ATTACHMENT “A” – Planning Discussion

FILE: SP 1/2023 (Proposed Amending By-law No. 26/2023)

SUBJECT: Proposed Naawi-Oodena Secondary Plan

RECOMMENDATION: Approval with amendments

Figure 3 – Land Use Policy Areas

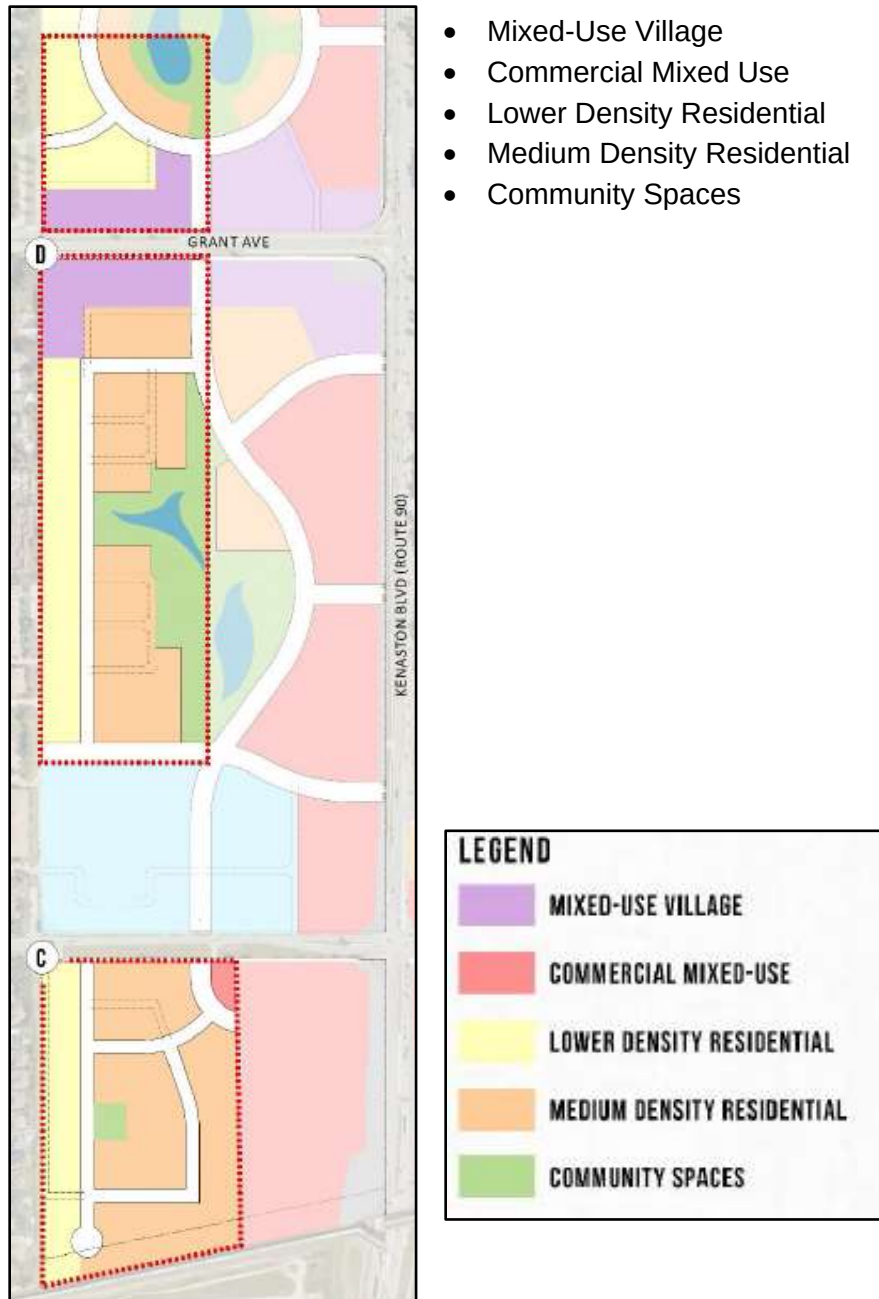
The location and configuration of stormwater retention ponds depicted on the Land Use Policy Map (see Figure 3 of this Report) are assumed to be generally accurate. However, it is understood that the location and configuration of these ponds in the Plan Area may be adjusted or re-envisioned to the satisfaction of the City of Winnipeg during the subdivision and rezoning application process.

Figure 6 – Minor Collector Type A

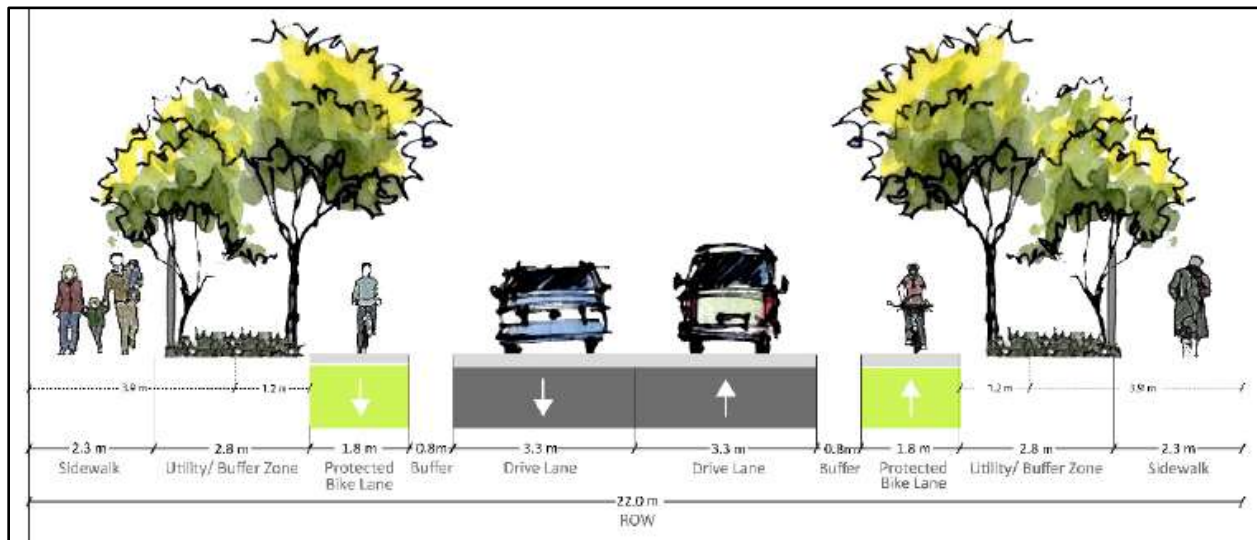
Policy 4.1.2(4)(i) includes descriptions of the design of the three types of Minor Collector Streets; local streets and active transportation paths (AT). These descriptions are supported by illustrations containing street cross sections (as exemplified in Figure 6 – Minor Collector Type A).

Some of the items and measurements presented in the figures referenced by the policies are inaccurate, or undescribed as exemplified in Figure 7 – Minor Collector Type B. For instance:

- Figure 4.2 includes a 2.4m bike lane that contains trees, as well as a 3.0m Utility/Buffer zone that contains an AT Pathway
- All of the figures, other than Figure 4.1 (Minor Collector Type A), include trees planted immediately adjacent to the roadway
- All of the figures include a 1.2m measurement adjacent to the roadways or AT Pathways, which appears to contain trees. It is not clear what this space is meant to represent as it is not referred to elsewhere in the Proposed Plan.

The Public Service has the following concerns with the minor collector streets described in policy 4.1.2(4):

- Street lane widths of 3.3m presented in the Proposed Plan are much narrower than City of Winnipeg standard of 5.0m for an undivided Minor Residential Collector with a 22.0m right-of-way. In addition, a minimum 6.0m of paved surface is required to allow for fire trucks to navigate as well as operate during a fire emergency.
- The boulevards in the Proposed Plan do not provide enough space to accommodate snow storage or underground utilities. Snow storage requires at least 4.0m of space on either side of a street in addition to the space required for a sidewalk (~6.0 total space). Plus, an additional 3.0m would need to be added to the ROW if a bike lane is to be included.

Policy 4.1.2(4)(i)(b) be reworded as follows:

Minor Collector Type B - The Type B street is a 22.0m wide two-way street with one driving lane ~~of 3.3m~~ in each direction. It is a two-lane roadway which includes chicane, with parking, parklets, public art, etc. integrated into the chicanes in an alternating fashion and thereby facilitating traffic calming measures to reduce vehicular speed and increase safety and mobility. The pedestrian and cycling facilities are located consolidated into a 5.3m wide multi-use path on the left side of the cross section with 2.3m designated for walking Facilities and 3.0m designated for cycling facilities. A 2.3m wide pedestrian sidewalk is also provided at the right end side of the street. Both are buffered from the driving lanes with a 2.4m wide utility/buffer zone.

Figure 7 – Minor Collector Type B

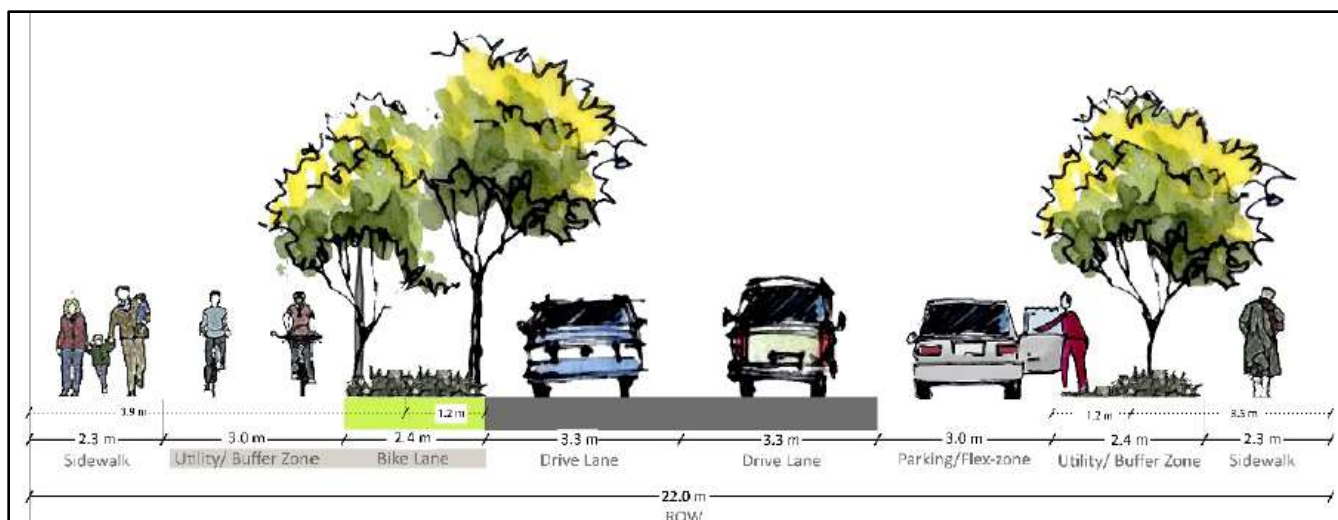
In addition, the Winnipeg School Division has requested that roadway widths, curves and intersection turning radii (at least 36 feet) be designed to accommodate a 77-passenger school bus. Potential solutions could include a bike lane with a mountable curb; however, these design details will be worked out and likely included in a development agreement during the subdivision/rezoning phase.

The ability to accommodate fire trucks and school buses is further complicated by chicanes, and traffic circles included in the Proposed Plan.

~~Traffic calming circles are recommended at collector to collector street intersections along the Type B street to reduce speeds. Figures 4.2, 4.3, 4.4, 4.5 illustrate varied configuration for the Type B street.~~

The following figures be removed from the Proposed Plan:

- Figure 4.2 – Minor Collector Type B
- Figure 4.3 – Minor Collector Type B with Outdoor Seating
- Figure 4.4 – Minor Collector Type B Section with Parking
- Figure 4.5 – Minor Collector Type B with a Bike Share Station
- Figure 4.6 – Minor Collector Type C with Parking
- Figure 4.7 – Minor Collector Type C with Outdoor Seating

Figure 8 – Minor Collector Type C

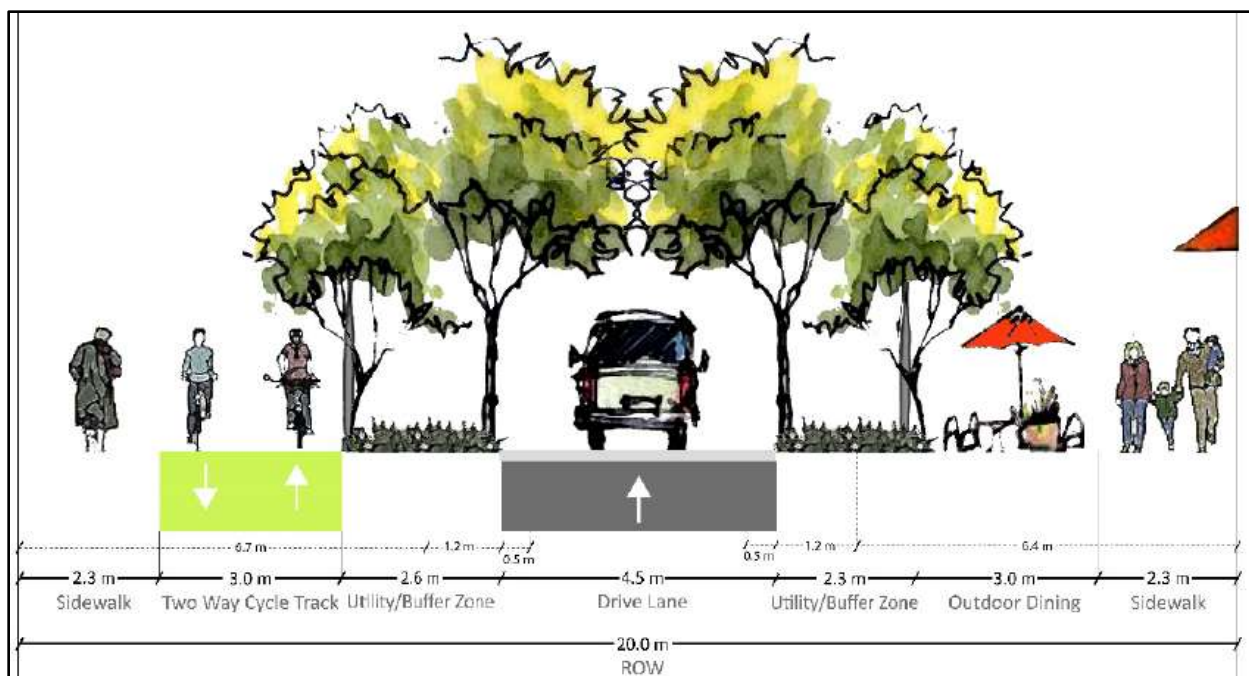
The cross section of Minor Collector Type C presented in Figure 4.7 of the Proposed Plan is of particular concern (See Figure 8 – Minor Collector Type C) as it includes a single 4.5m drive lane (with 0.5m striping on both sides) with chicanes in a 20.0m right-of-way. As previously mentioned, this street type is only applied to the circular roadway that services the northern most portion of the Plan Area.

The description for the Type C Minor Collector street contains measurements and features (i.e. chicanes) that result in a roadway that is not able to meet the Fire Department safety standards.

While it is understood that the roadway cross sections presented in section 4.1.2(4) are suggestions, as opposed to requirements, it would be misleading to adopt policies that present standards which may not be accepted during the subdivision and rezoning phase of development.

Policy 4.1.2(4)(i)(c) be reworded as follows:

Minor Collector Type C – The Type C street is a 20.0m wide one-way street with the ~~4.5m wide~~ driving lane circulating in an anti-clockwise direction. The lane is visually narrowed with ~~0.5m~~ striping on either side to reduce vehicle speeds. The one-way operation is intended to deter shortcutting though the north area to bypass the Route 90/Grant Avenue intersection and to simplify internal intersection configurations along its length. The street design ~~is a single lane chicane, with parking, parklets, public art, etc. integrated into it, that~~ facilitates traffic calming to reduce vehicular speed and increase safety. The pedestrian and cycling facilities are ~~located consolidated into a 5.3m wide multiuse path on the left side of the street with 2.3m designated for walking facilities and 3.0m designated for cycling facilities.~~ A ~~2.3m wide pedestrian~~ sidewalk is also provided on the right side of the street. Both are buffered from the driving lanes with a ~~2.3-2.6m wide~~ utility/buffer zone. ~~See Figures 4.6 and 4.7 below~~
